## **2019 GROUP B PROPOSED CHANGES TO THE I-CODES ALBUQUERQUE COMMITTEE ACTION HEARINGS**

2018-2019 Code Development Cycle, Group B (2019) Proposed Changes to the 2019 *International Codes*

## **IBC General Code Change Proposals**

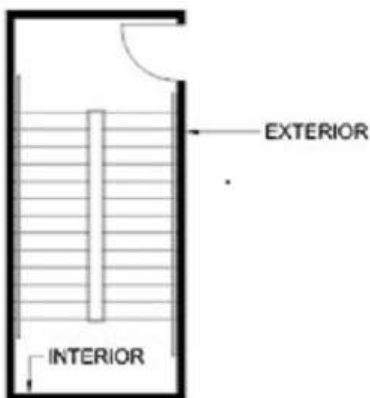
**[BS] 403.2.3.1 Wall assembly.** The wall assemblies making up the enclosures for *interior exit stairways* and elevator hoistway enclosures shall meet or exceed Soft Body Impact Classification Level 2 as measured by the test method described in ASTM C1629/1629M when tested from the exterior side of the enclosures.

**[BS] 403.2.3.2 Wall assembly materials.** The exterior face of the wall assemblies making up the enclosures for *interior exit stairways* and elevator hoistway enclosures ~~that are not exposed to the interior of the enclosures for interior exit stairways or elevator hoistway enclosure~~ shall be constructed in accordance with one of the following methods:

**Reason:** This proposal clarifies which side of these enclosure wall assemblies must be tested for abuse and impact resistance. 403.2.3.2 currently states that the exterior side is tested, but it does so in very confusing language. This proposal cleans that up and reiterates the point in 403.2.3.1. Also note that, due to the manner of construction of these enclosure wall assemblies, testing from the exterior side represents the worst case. This proposal also cleans up 403.2.3.4, which currently implies that 403.2.3.1 and 403.2.3.2 both apply to hard body impact testing, which is not the case. The first section is for soft body impact testing. This is simply a grammatical revision that clarifies the intent of the section.

For clarification, the exterior side is the side which does not face into the enclosure, as the figure below illustrates.
